**WILLIAMSON COUNTY, TEXAS**CHANGE ORDER NUMBER: 17

Contractor: James Construction Group ☒ Yes ☐ NoProject Name: FM3349 at US 79Change Order Work Limits: Sta. 47+00 to Sta. 47+50Type of Change (on federal-aid non-exempt projects): Minor (Major/Minor)Reasons: 1A (3 Max. - In order of importance - Primary first)

**FM3349 at US 79  
Williamson County Project No. 22IFB139**

**Change Order No. 17**

**JONAH WATER S.U.D.**  
WILLIAMSON COUNTY, TEXAS  
2021 - FM 3349, UTILITY ADJUSTMENTS  
WATERLINE ALIGN. "A"; STA. A-39+50 TO A-47+50

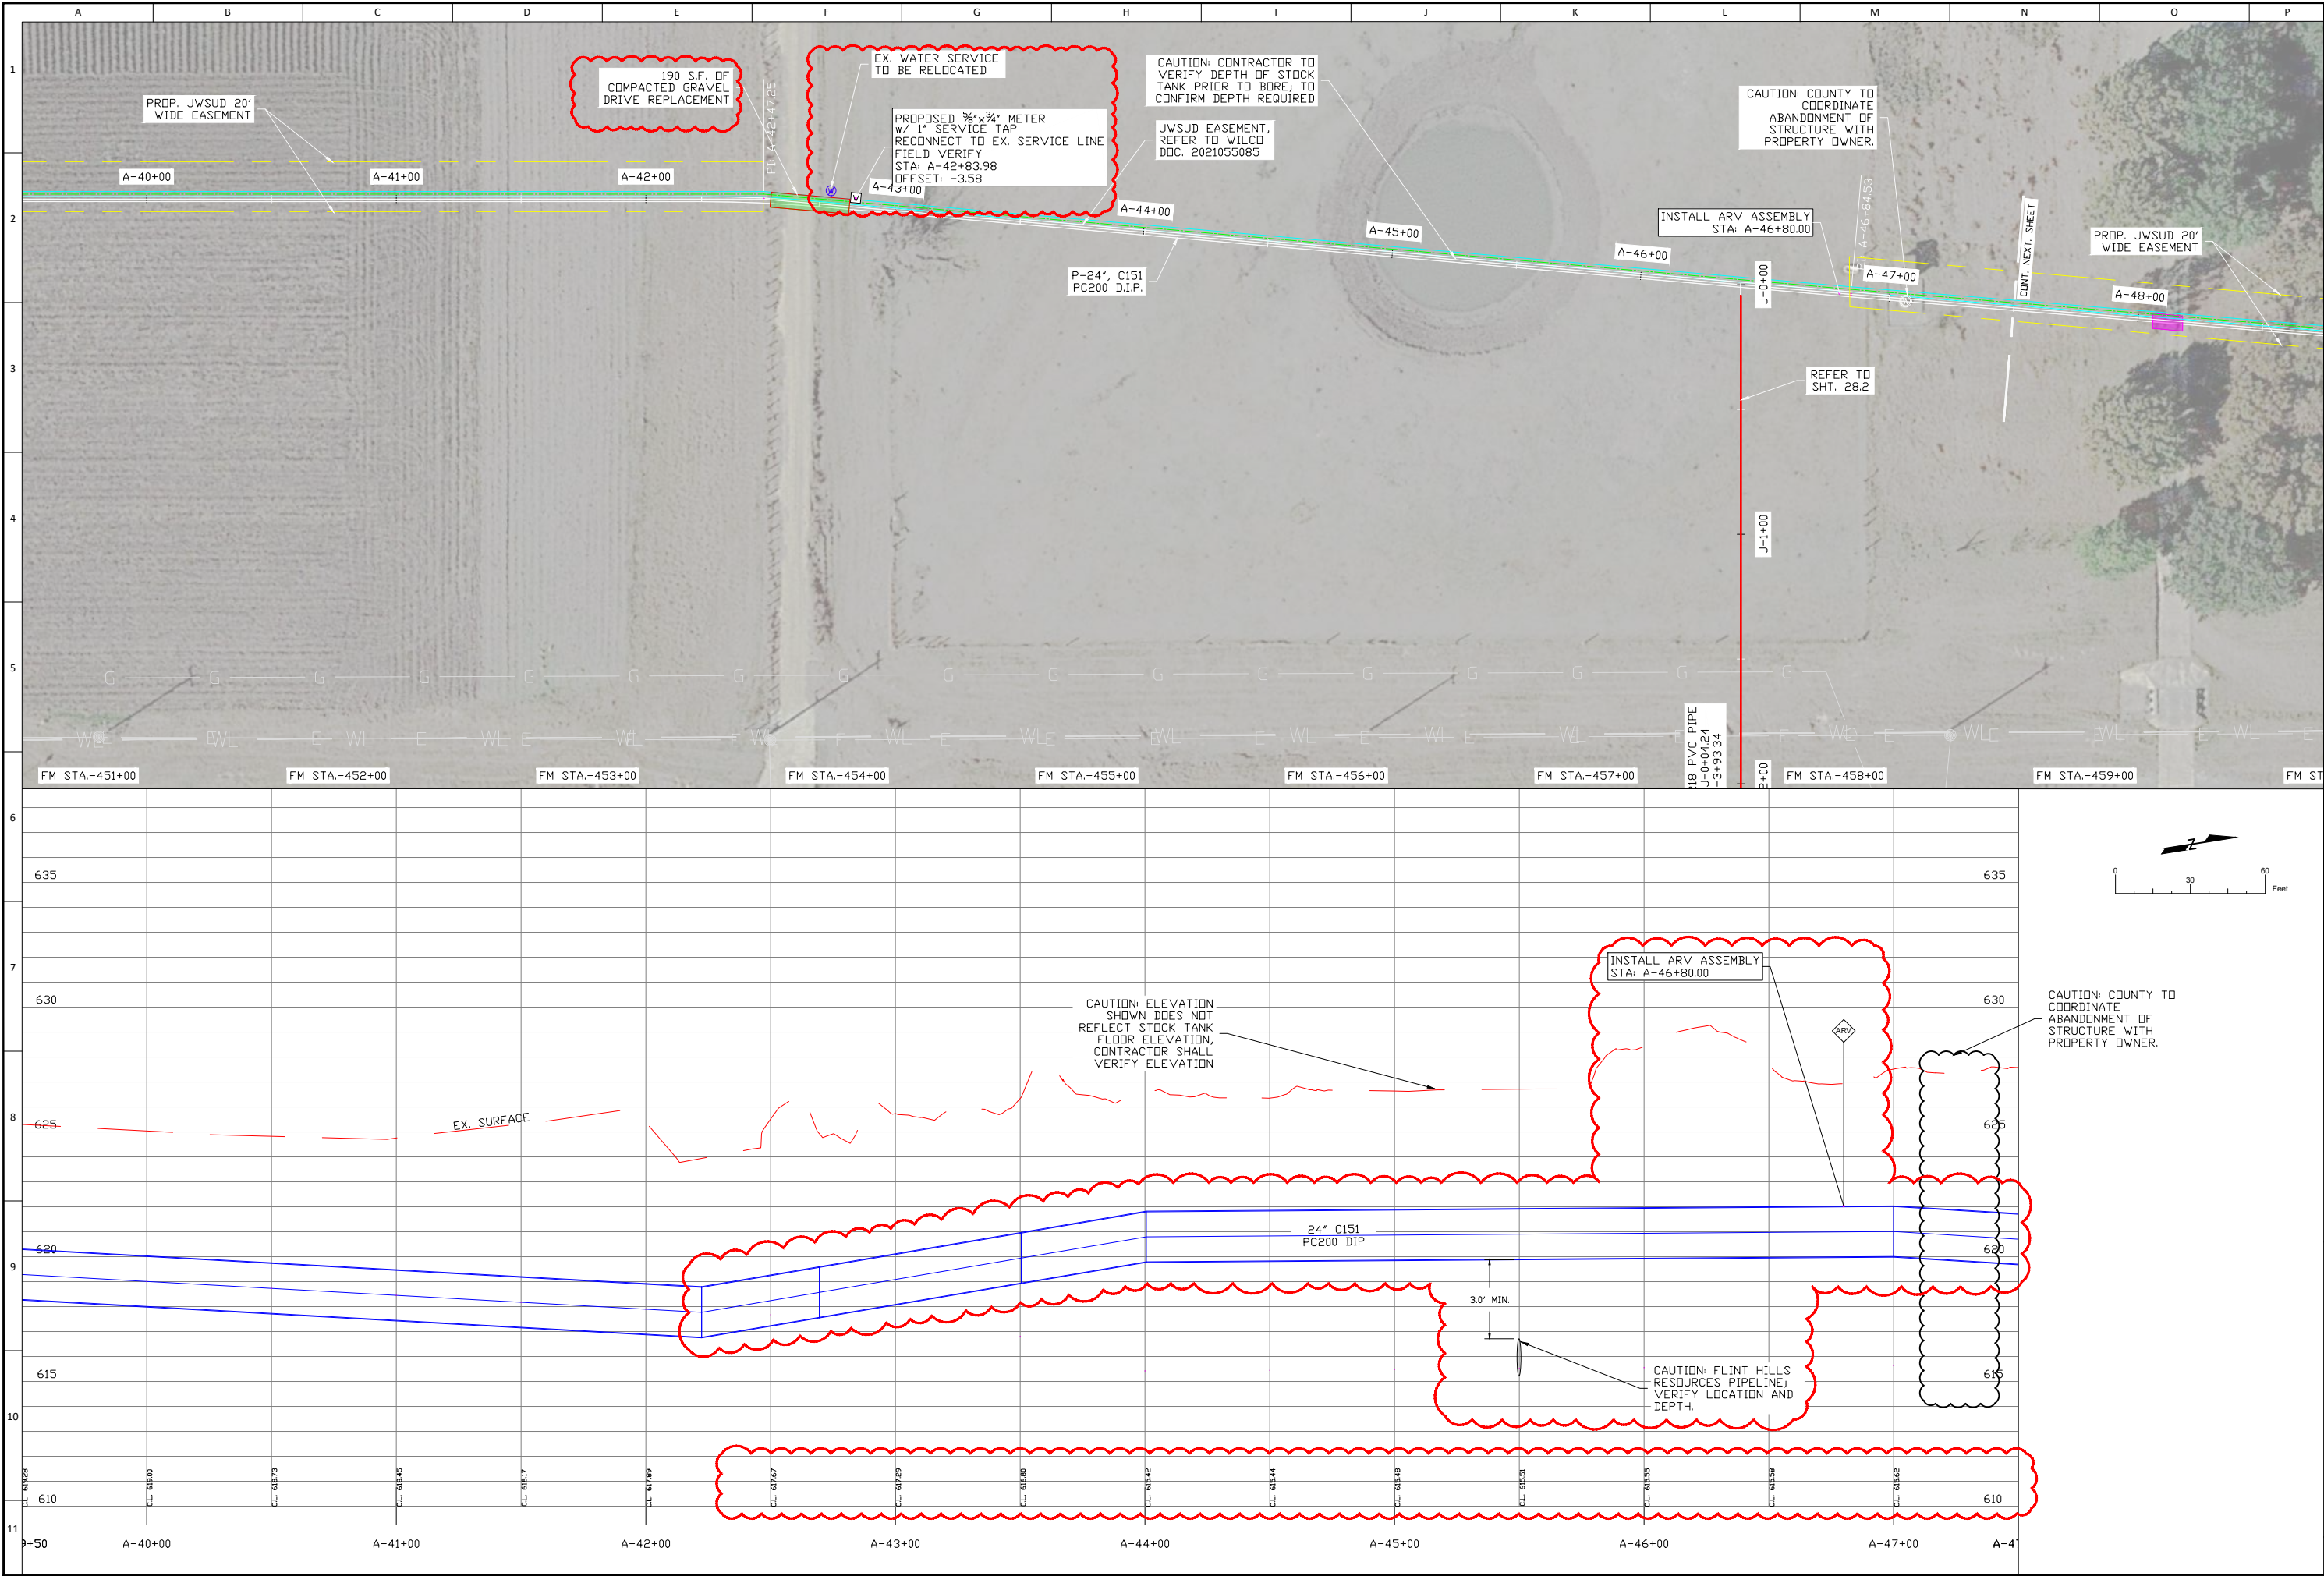
This Change Order provides compensation to the Contractor for abandoning the water well and removing the pump house, ancillary pipes and fittings, electrical power supply, concrete slab, and performing dirt work within the project right-of-way (ROW) and the Jonah SUD water line easement. The roadway plans do not show the well, and the Jonah water line plans include a note stating, "County to coordinate abandonment of structure with property owner." However, a pay item was not included in the original Contract.

Narrative: REMOVE WATER WELL PUMP HOUSE AND CONC SLAB STRUCTURE - PLUG &amp; ABANDON WELL PER TCEQ SPECIFICATIONS- HAUL OFF ALL MATERIALS &amp; GRADE AREA
